Contract #: 04-0120F4Cty: SF/ALA Rte: 80 PM: 13.2/13.9File #: 69.25B**QUALITY ASSURANCE -- NON-CONFORMANCE REPORT****Location:** Changxing Island, Shanghai, P.R. China**Report No:** NCR-000435**Prime Contractor:** American Bridge/Fluor Enterprises, a JV**Date:** 13-Sep-2009**Submitting Contractor:** Zhenhua Port Machinery Company, Ltd (ZPMC), Changxing Island**NCR #:** ZPMC-0409**Type of problem:****Welding****Concrete****Other****Welding****Curing****Procedural****Bridge No:** 34-0006**Joint fit-up****Coating****Other****Component:** OBG Segment 1AAE Bottom Panel**Procedural****Procedural****Description:****Reference Description:** Unapproved base metal repair to correct distortion at 1AAE Bottom Panel**Description of Non-Conformance:**

Job Name: SAS Superstructure

Subject: NCR No. ZPMC-0409

Reference Description: Unapproved base metal repair to correct distortion at IAAE Bottom Panel

Draft of Welding Discontinuity:

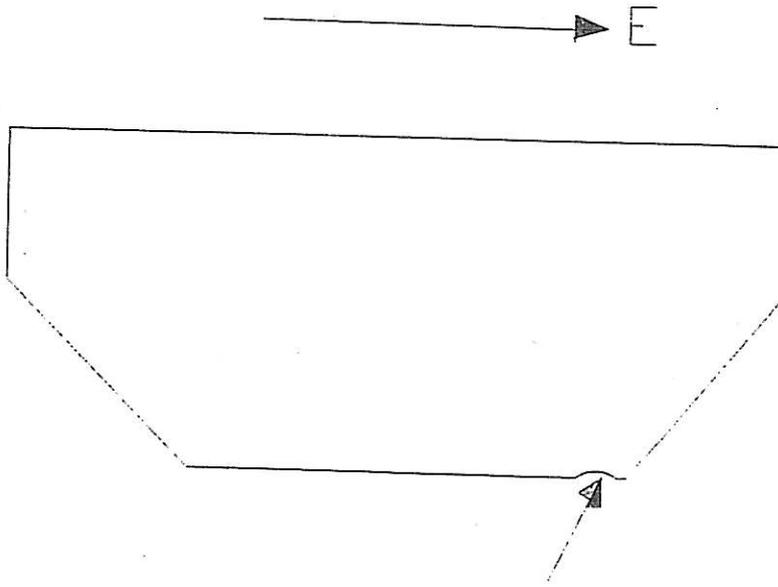
After inspection: the flatness exceeded requirement at 1AAE south side, 200mm in length, 200mm in wide, it needed to build up, and the detail sees the following draft.

1. 焊接变形和制作误差。
1. Weld distortion and fabricate error.

1. 准备一个正确的接头型式, 具体参照相应的返修WPS ;
 2. 将修补区域打磨光滑, 开始和结束的接头交错布置 ;
 3. 对修补区域进行VT与MT检测 ;
 4. 根据批准的返修焊接工艺规程 (WPS) 进行预热及焊接 ;
 5. 将修补区域打磨与母材或相邻焊缝平齐 ;
 6. 对修补区域作100%VT与MT检测 ;
-
1. Prepare excavation according to the approved repair WPS.
 2. Grind the repaired area to a smooth and shiny finish, with tapered ends, to ensure staggered starts and stops.
 3. VT and MT the repair area.
 4. Preheat and weld according to the relevant repair WPS.
 5. Grind the repaired area flush with base metal or the adjacent weld.
 6. Perform VT and MT over 100% of the repair area.
